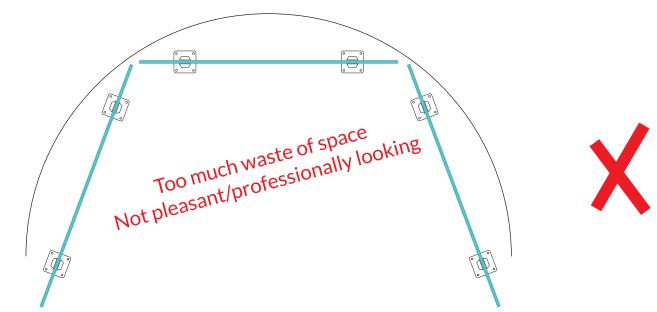
STRAIGHT LINE (standard)

SLIGHT CURVE (Might be feasible using straight glass panels)

SHARP CURVE (or spiral) (Not suited for glass railings using straight glass panels)

STRAIGHT LINE (standard)

SLIGHT CURVE (Might be feasible using straight glass panels)

SHARP CURVE (or spiral)
(Not suited for glass railings using straight glass panels)

Too much waste of space Not pleasant/professionally looking Excessive cutting

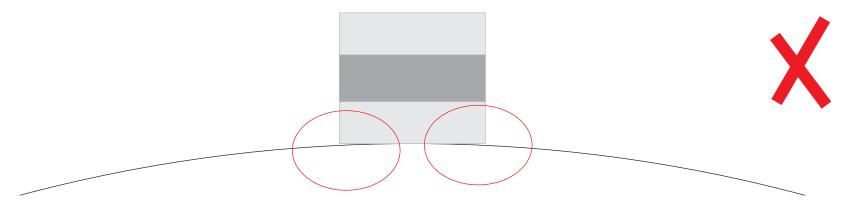
Hardware (of any kind) won't be installed flat on the curved fascia.

There's no alignment between hardware in order to install the glass.
